Model: 350, 500, and 750 Ton

Top Drive

Product Bulletin # TDS-141

Upper Link Modification

Figure 2: Upper Link Safety Wire Detail

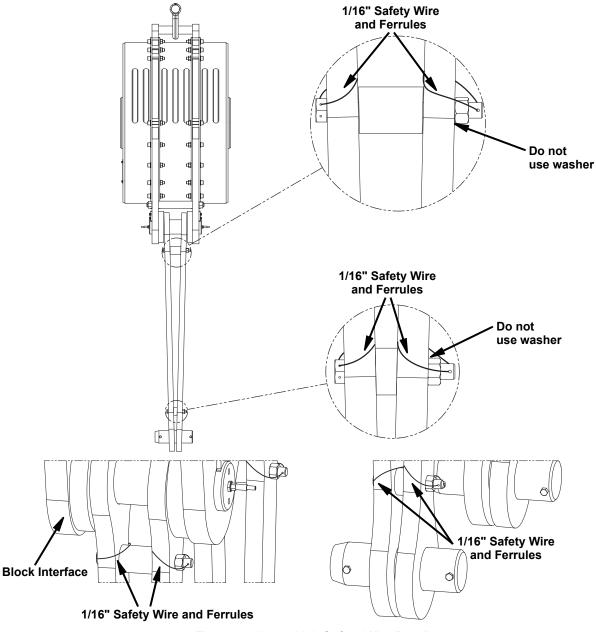
- 4. Install safety wire and ferrules on bolts as follows: (See Figure 2)
 - a. Remove washers. Washers are not required for this assembly.
 - b. Torque lock nuts to 400 ft-lbs (360-462 ft-lbs).
 - c. Secure a loop of safety wire through the bolt head and around adjacent upper link and another loop of safety wire through the bolt end and around adjacent upper link. Ensure excess slack is removed.
